## **Product Support Bulletin 2015-002**

Maintenance of Way ~ Work Equipment Bulletin

SUBJECT: Cab door latch open release handle replacement.

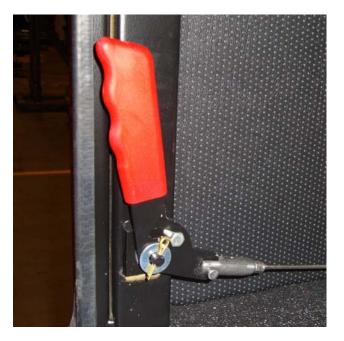
**SUMMARY:** A redesigned latch open release handle, P/N 42030163 has been developed by Nordco. This latch handle is the one that releases the door from inside the cab when the door is in the open position (latched against cab wall). The handle has been redesigned to rest in a more vertical position than in the horizontal position it is currently in. This handle is also available with kit P/N 98310034 which will take of both cab doors. The kit also includes a replacement ¼" bolt, which limits excess travel of the handle.

- **IMPACT:** The current horizontal position allows the handle to extend in the cab door way opening a couple of inches, leaving it in position to get damaged or stepped on. The replacement handle allows it to be clear of the opening to prevent any possible damage.
- ACTION: Verify your machine is the model and serial number range listed on page 1. If your machine is in those groups you should order Nordco Kit P/N 98310034. The replacement is very simple. It only requires removing a couple of cotter pins and a clevis pin to take off the old handle and then install new handle and cotter pins.
